AGENDA
CHASKA PLANNING COMMISSION
ZOOM
Wednesday, December 09, 2020
7:00 PM

CHASKA PLANNING COMMISSION MINUTES Oct 14, 2020

To: Planning Commission
From: Matt Clark
Date: December 3, 2020
Subject: Harvest West North Preliminary Plan

Photo #1. Image of the proposed grading plan around the subject trees.

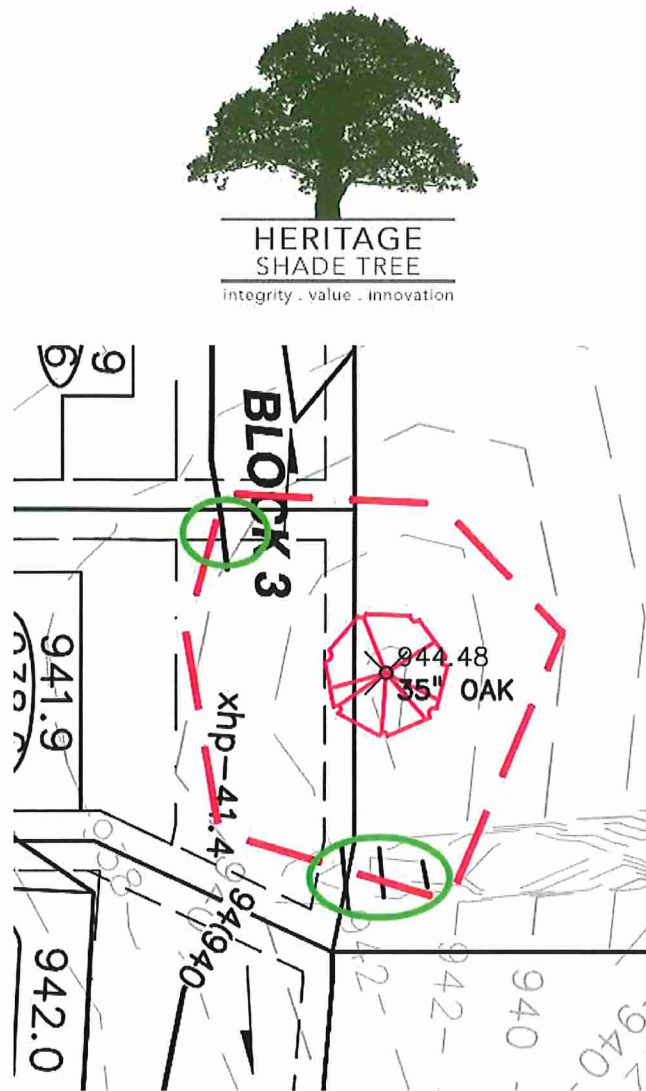
The applicant has submitted a tree survey and preservation plan as a part of their preliminary submittal. Tree Preservation will be an important piece of this development, specifically in the conservation corridor area and adjacent to the public park. The plan shows that a majority of the significant oaks are planning to be saved in this corridor. There are a couple oaks on the perimeter of the corridor that have been further evaluated in terms of layout of the westerly cul de sac; these include the 35 and 42 inch oaks on the east edge of the westerly cul de sac lots. Another further evaluated area includes a 32 inch oak on the north edge of the public park within lots 7 and 8 of Block 5. The developer has engaged an arborist to review these significant trees and has determined that they are in good health and will remain healthy through the course of construction with the grading limits proposed; there will be minimal impact areas but they will not be detrimental to the trees. Staff would point out that the Erosion Control Plan shows silt fencing to be located to protect the drip lines of such trees, however for the 42 inch oak there doesn't appear to be measures in place. It would be required that this oak tree also be treated similar to the other oak trees for silt fencing and revised on the final plans.

- 14. Provision that the 35 inch oak incorporates silt fencing around its drip line on the Erosion Control Plan consistent with the arborist's report, to be addressed at final submittal.
